In reply refer to:
P-2496

Subject: Dam Safety Incidents near Station 120+80 and Ames, Leaburg Canal
Development, Leaburg-Waltermville Project

This letter is to acknowledge the following letters and emails from you and your staff regarding the ongoing dam safety incidents on the Leaburg Canal Development of the Leaburg-Waltermville Project, FERC No. 2496:

Figure 1. Seepage Flow at Weir 120+80. Note heavy precipitation event April 2019.

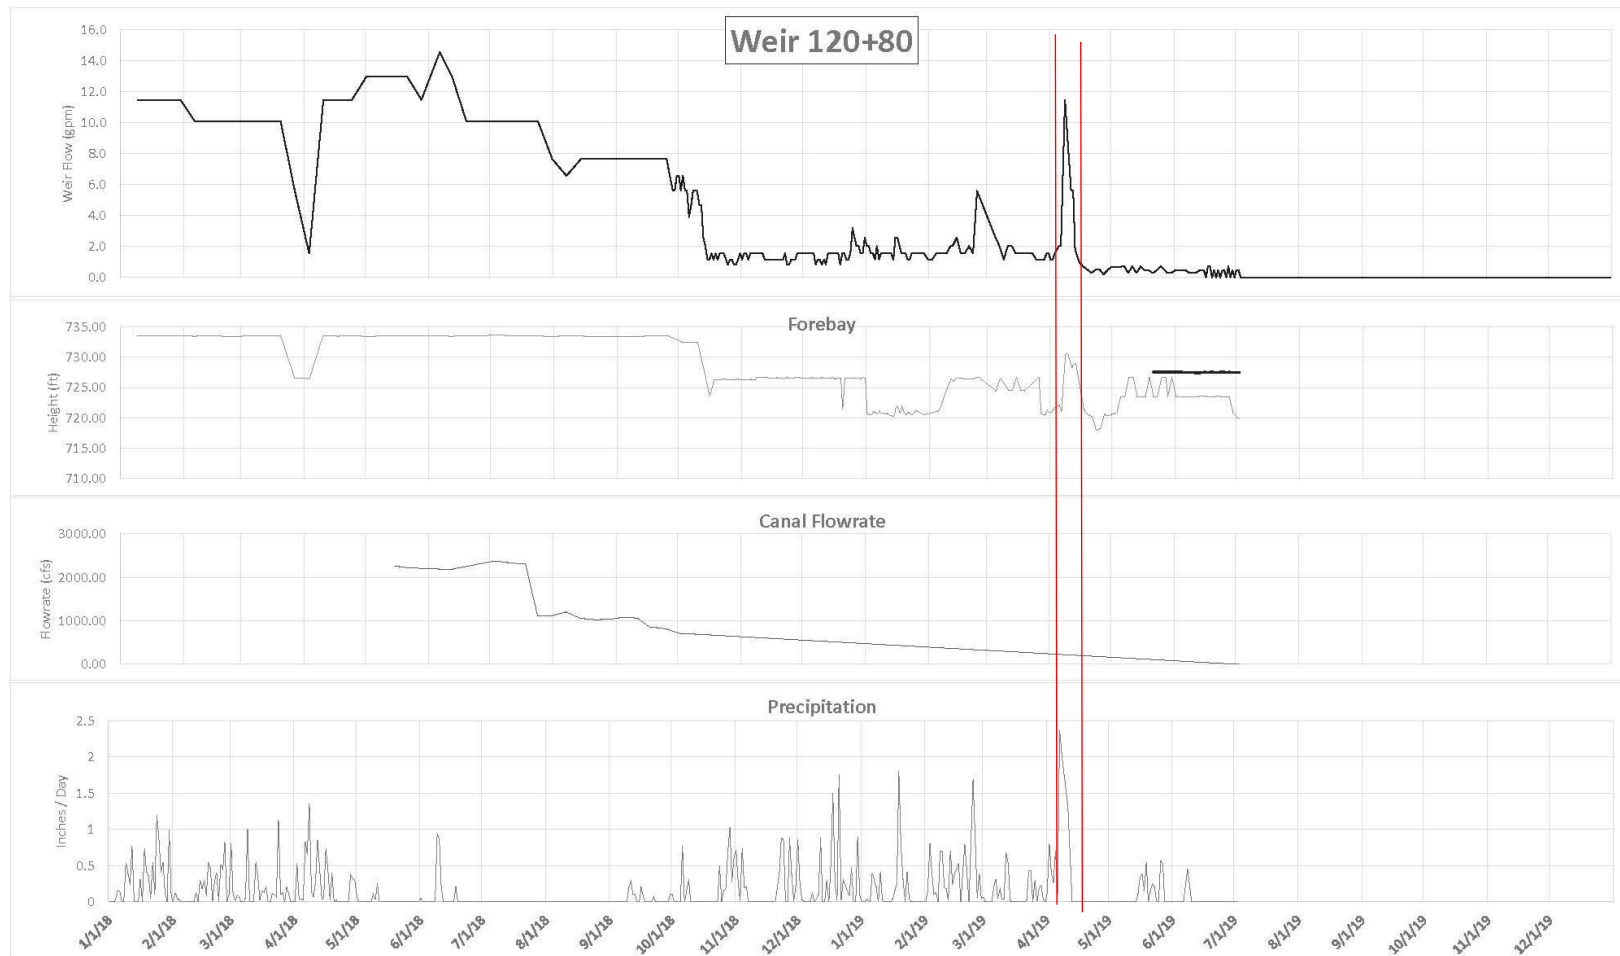
Between April 8 and 14, 2019, a significant precipitation event resulted in a canal water surface elevation of 730.5 feet, with the targeted drawdown elevation exceeded for six days (Enclosure, Figure 1). The following table, from Mr. Olmstead's April 17, 2019 email to Ms. Kristie Hartfeil, of this office, provides precipitation and forebay data during this event.

Daily weir instrumentation readings since October 1, 2018 indicate continuing seepage flow and sediment accumulation in the weir at Station 120+80, even at the drawdown elevation. This is a strong indicator that internal erosion of the canal embankment continues to occur and the current drawdown is insufficient. During the April 2019 precipitation event, EWEB staff observed a 24-foot-wide by 10-foot-high slough on of the interior side of the canal embankment at Station 125+00. While the canal water surface was above the drawdown target elevation, weir flows at Station 120+80 spiked to pre-drawdown flows.

2. Decrease the water surface level in the Leaburg Canal. EWEB is required to make every additional effort to reduce the canal water surface to an elevation where sediment is no longer being transported at Station 243+00, or to a low enough elevation that a breach of the canal would not pose a threat to downstream lives and property.
3. Provide additional discharge capacity. During a heavy precipitation event, EWEB will be unable to maintain the required drawn down elevation with the existing gate structures. EWEB is directed to find alternative means for discharging excess flows from Leaburg Canal to maintain the required drawdown water surface elevation.

Figure 2. Seepage Flow at Weir 243+00. Note heavy precipitation event April 2019.

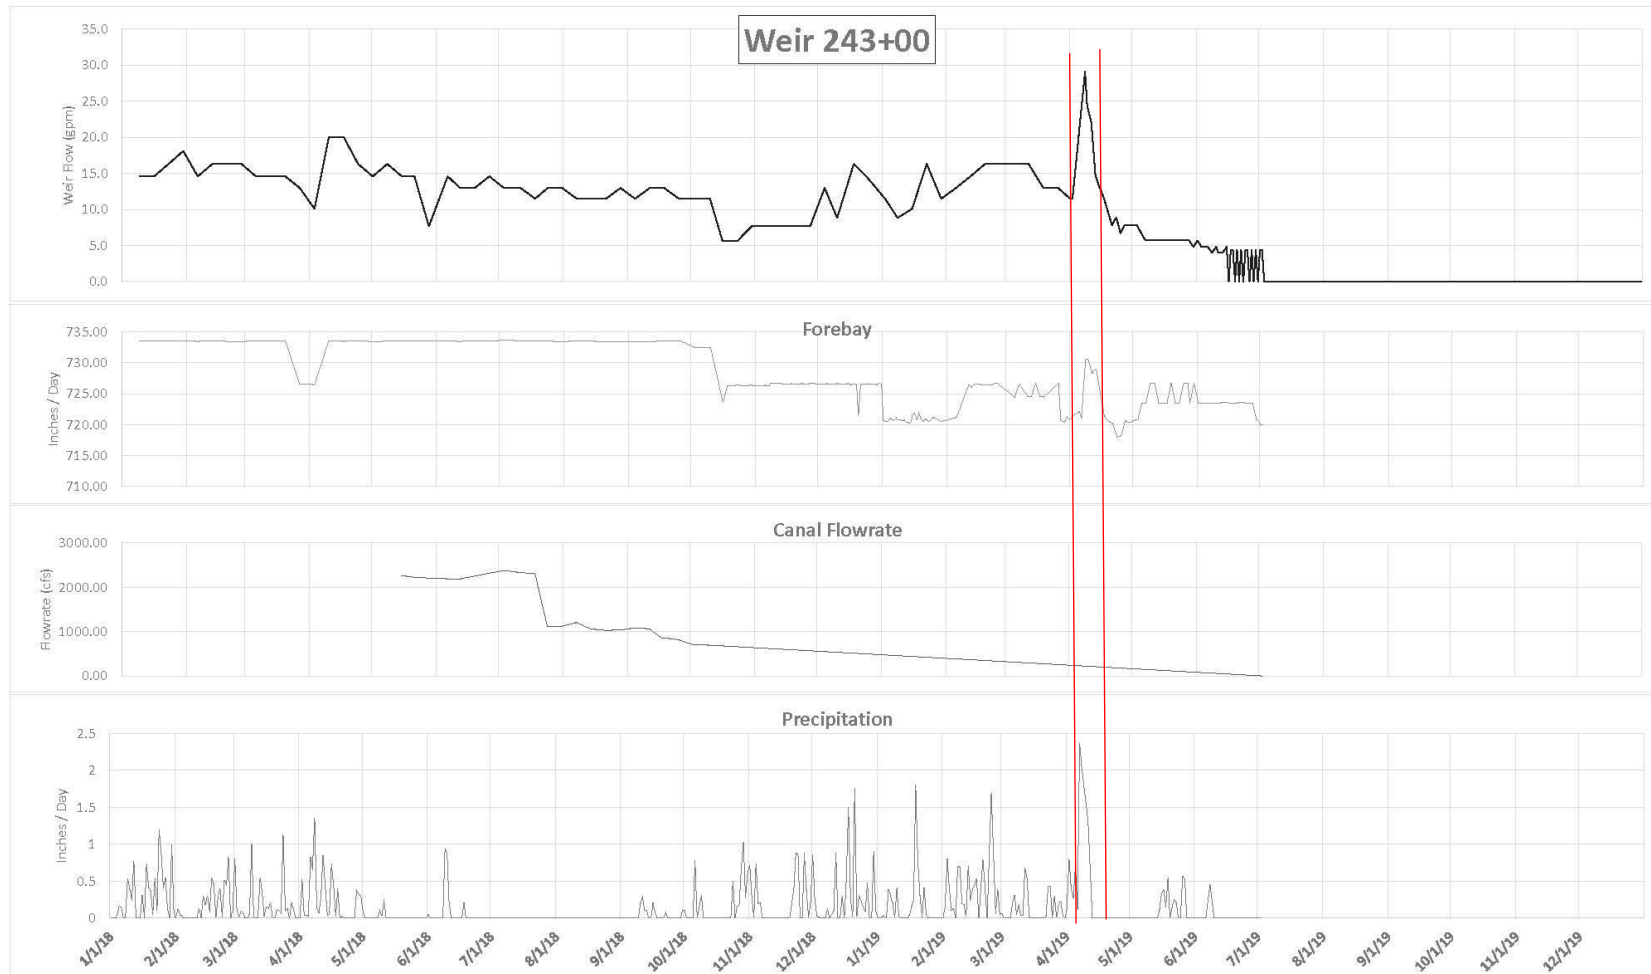
During an April 3, 2019 site visit to observe the geotechnical investigation at Station 120+80, D2SI-PRO staff observed a void above the weir box at Station 243+00

and tension cracks on the downstream face of the canal embankment near Station 237+00. The weir box at Station 243+00 is one of the oldest along the 90-year-old canal and has a history of significant seepage flows and sediment accumulation. Prior to the canal drawdown, seepage flow rates from the weir at Station 243+00 had been increasing over time. D2SI-PRO staff have observed the weir box floor covered with sediment on numerous occasions, including the April 3, 2019 inspection. During the April 2019 precipitation event, the weir recorded its second highest flow in the past fourteen years. The threshold level for the weir at Station 243+00 is 22 gpm; the maximum recorded weir flow reached nearly 30 gpm during the event (Enclosure, Figure 2). All of these factors appear to indicate that internal erosion of the canal embankment is occurring at Station 243+00.
